+1.5V Power Rail:

+1.5V @ 10A Max
 $(V_{OUT} = 0.75 \times (1 + R1/R2))$

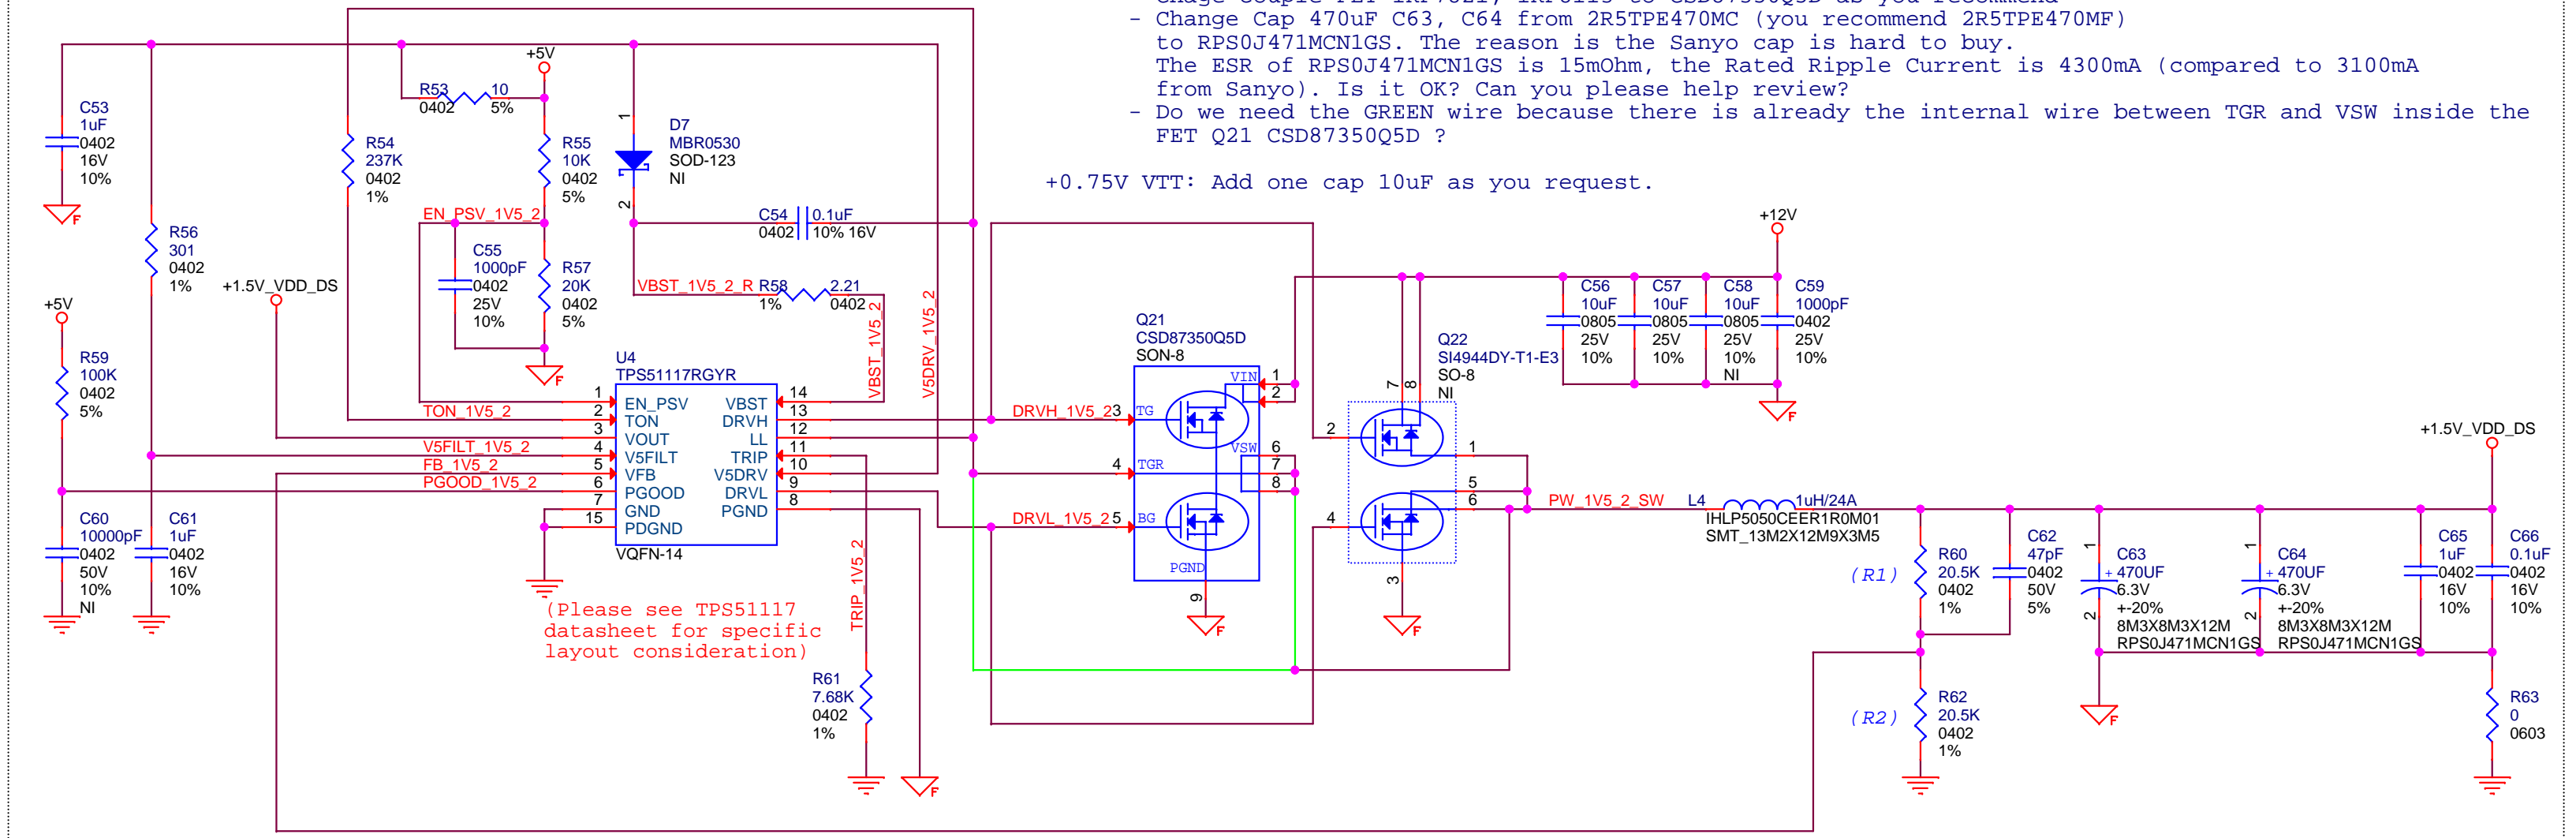
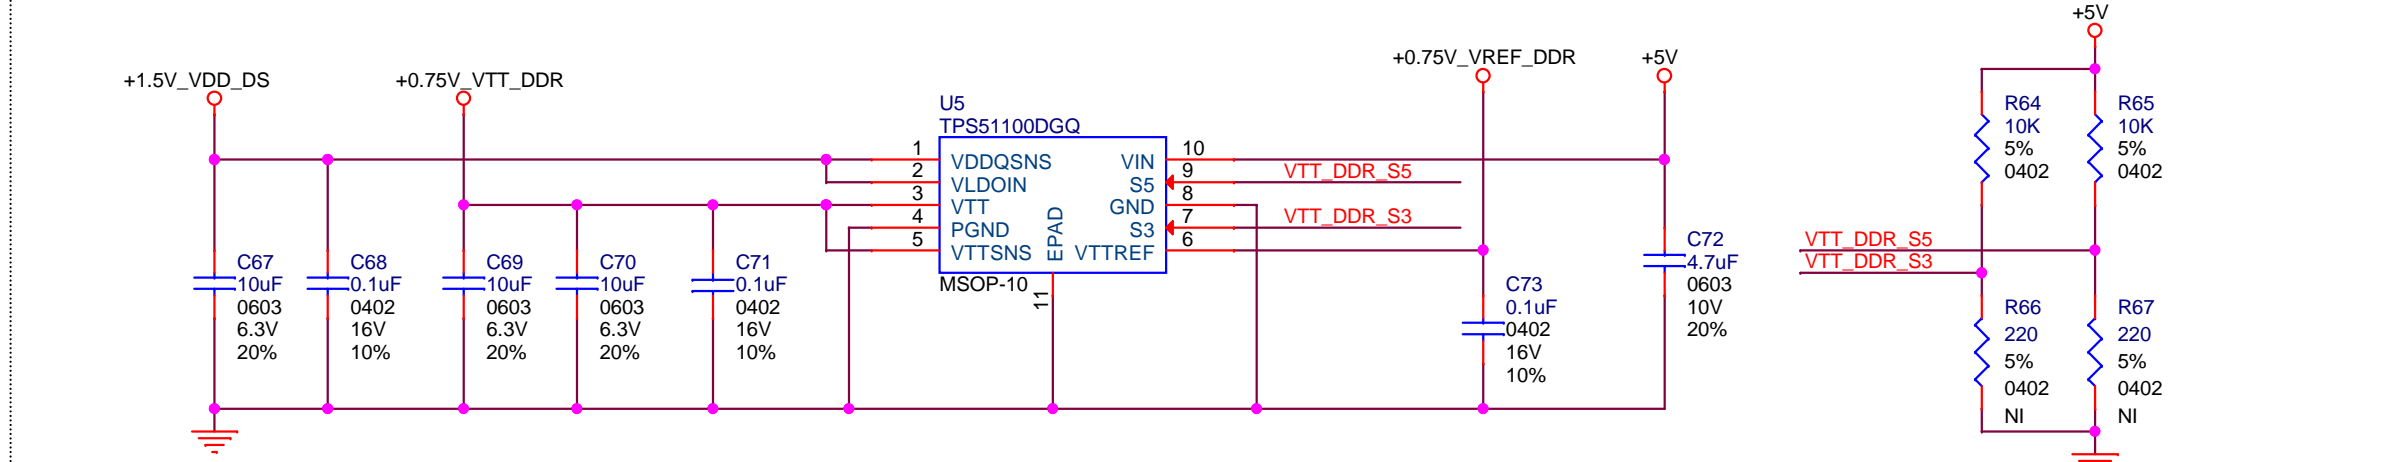
- Change R54 from 200K to 237K --> set switching frequency = 330KHz
- Change couple FET IRF7821, IRF8113 to CSD87350Q5D as you recommend
- Change Cap 470uF C63, C64 from 2R5TPE470MC (you recommend 2R5TPE470MF) to RPS0J471MCN1GS. The reason is the Sanyo cap is hard to buy. The ESR of RPS0J471MCN1GS is 15mOhm, the Rated Ripple Current is 4300mA (compared to 3100mA from Sanyo). Is it OK? Can you please help review?
- Do we need the GREEN wire because there is already the internal wire between TGR and VSW inside the FET Q21 CSD87350Q5D ?

+0.75V_VTT @ 3A Max

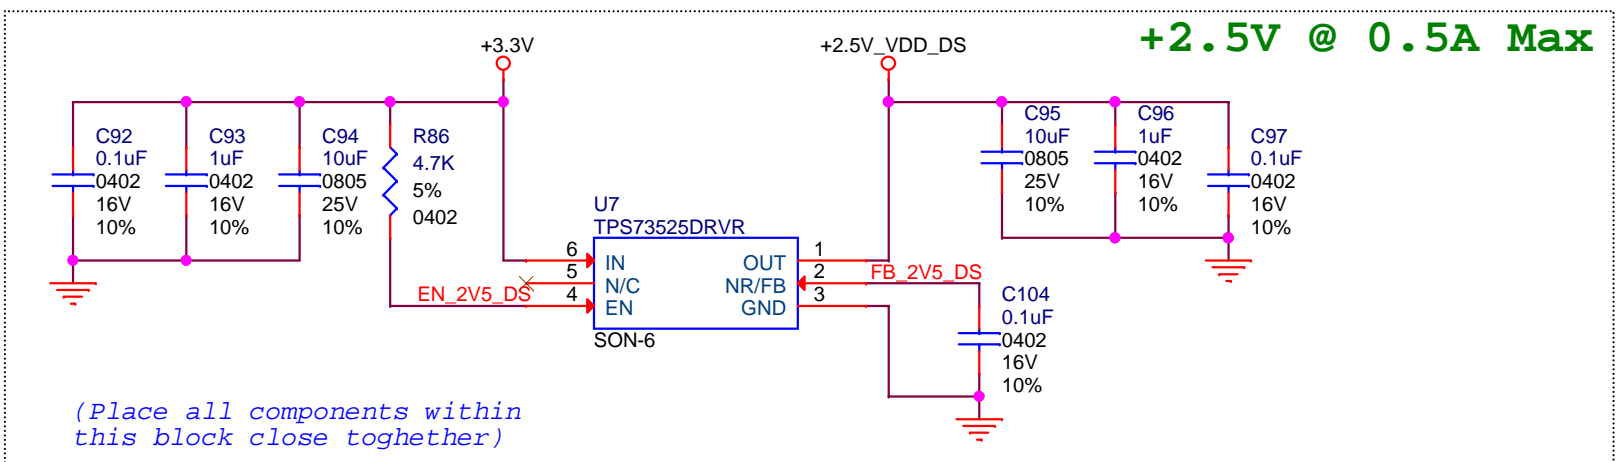
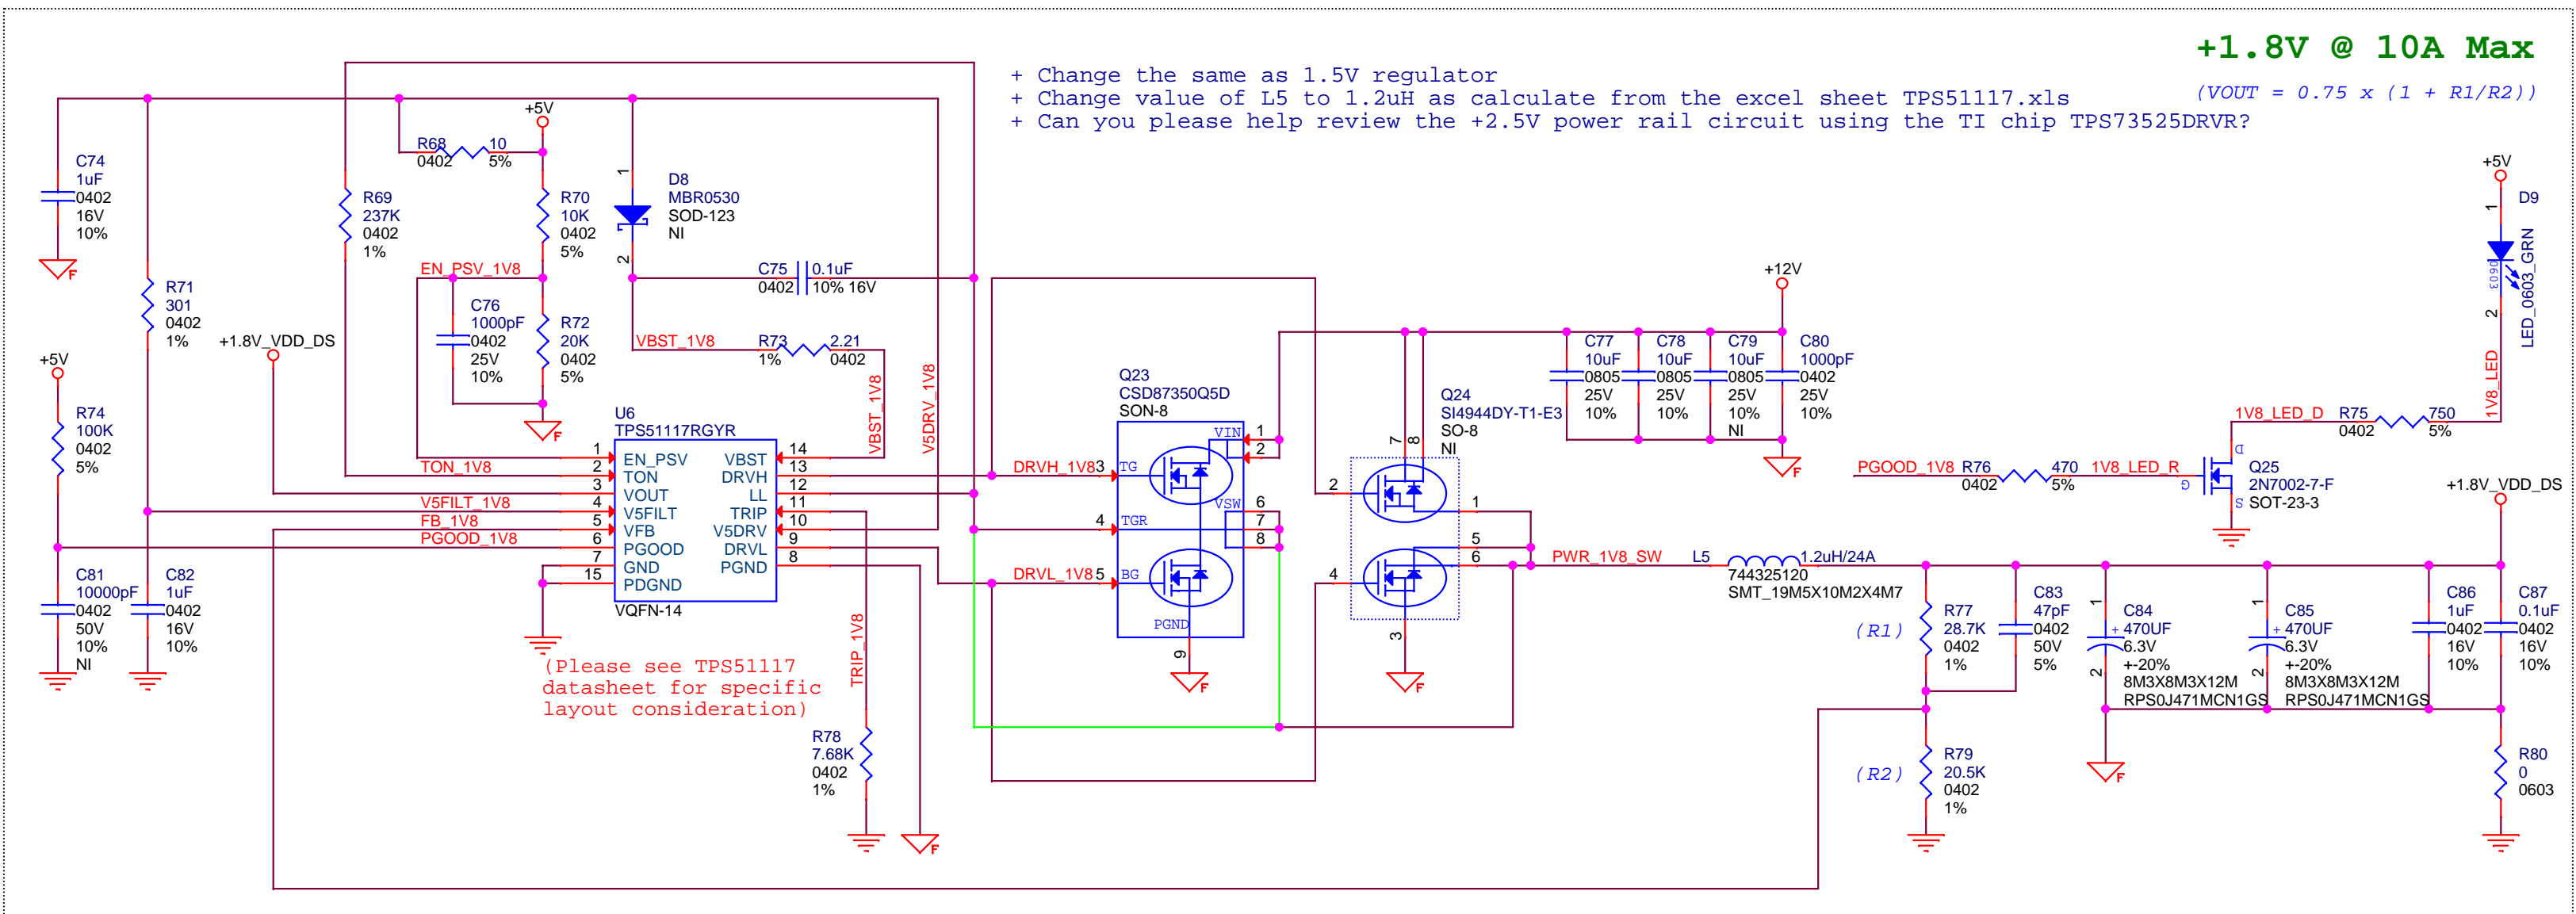
+0.75V VTT: Add one cap 10uF as you request.

+1.538V @ 2A Max

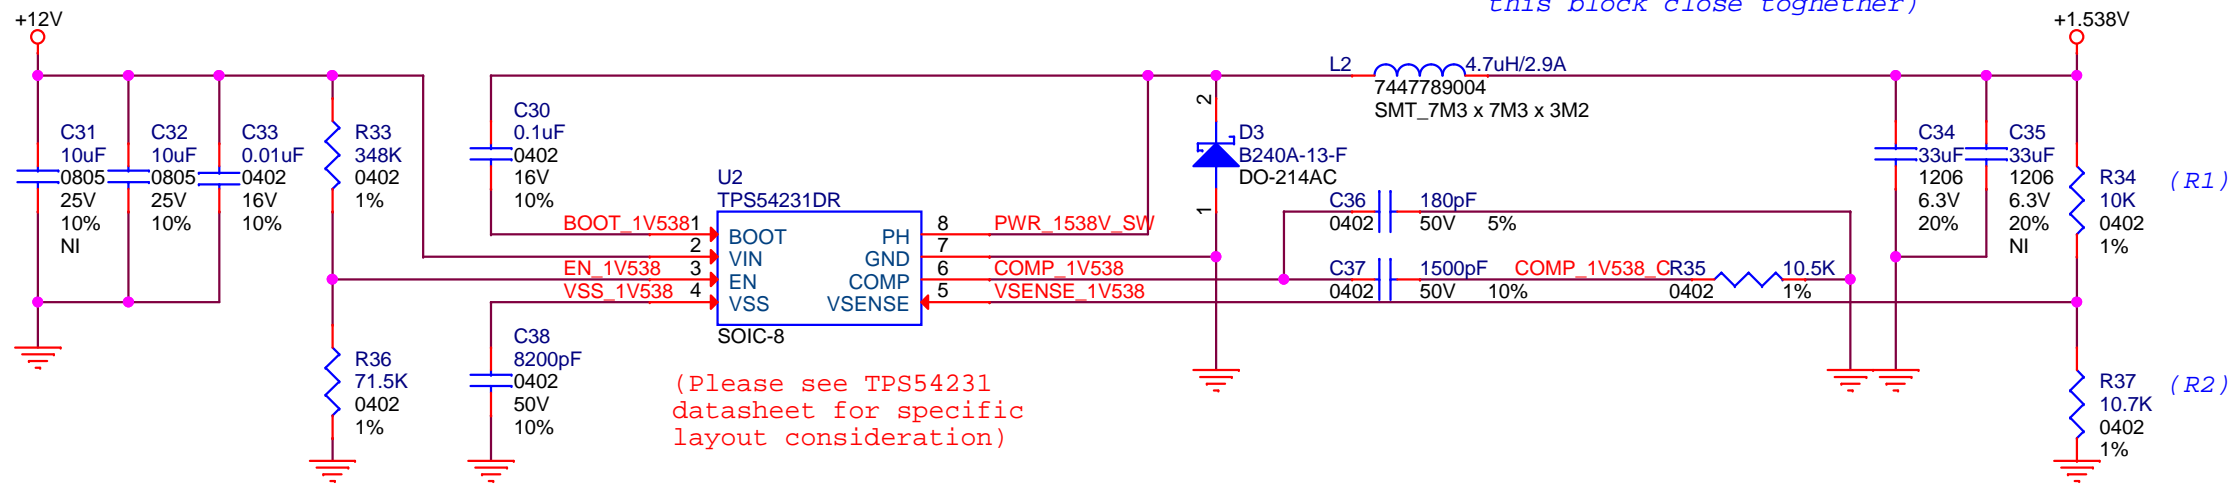
+ 1.538V power rail: change L2 to Wurth 7447789004 4.7uH, IDC = 2.9A, Isat = 3.9A. Is it OK?

+1.2V @ 2A Max

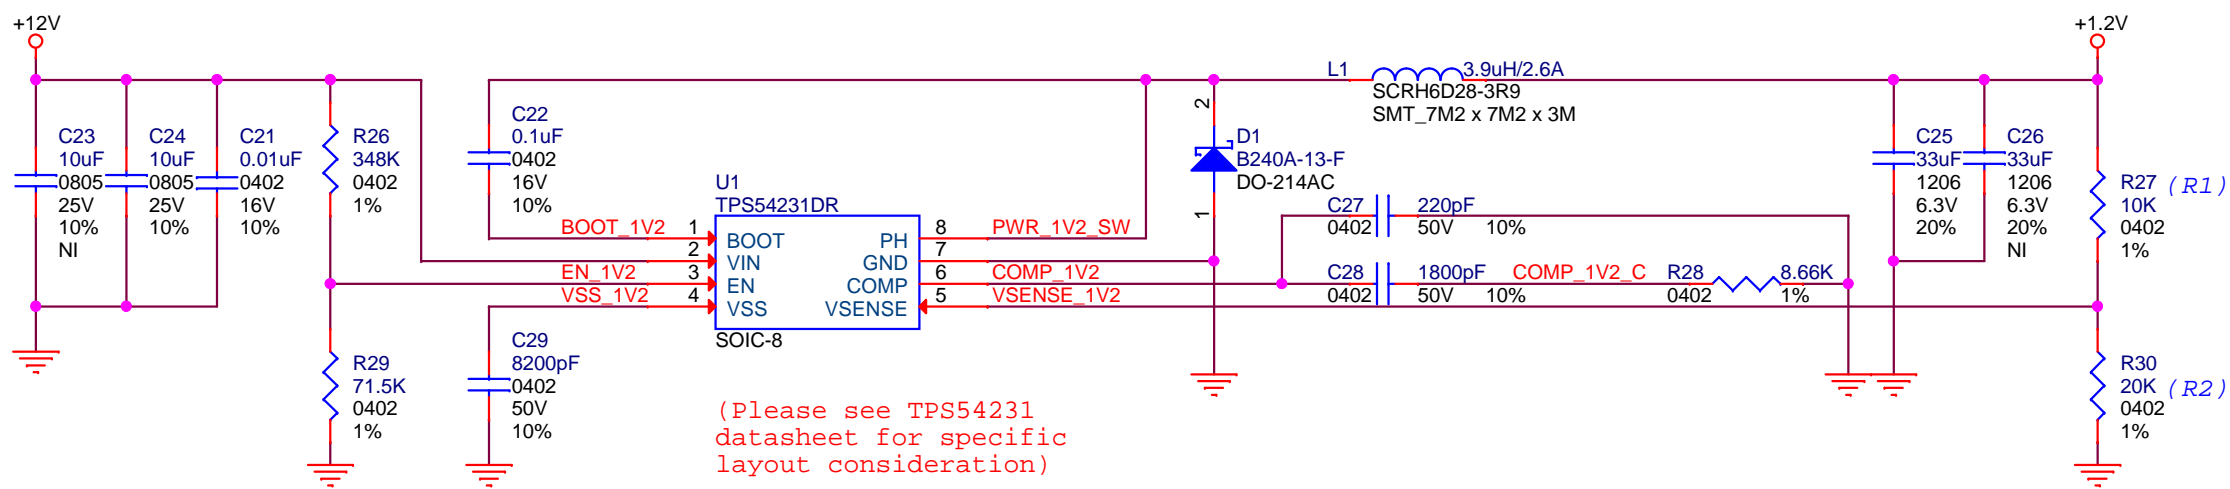
+ 1.2V power rail: change L1 to SCRH6D28-3R9 3.9uH, IDC= 2.6A, Isat = 2.6A. Is it OK?
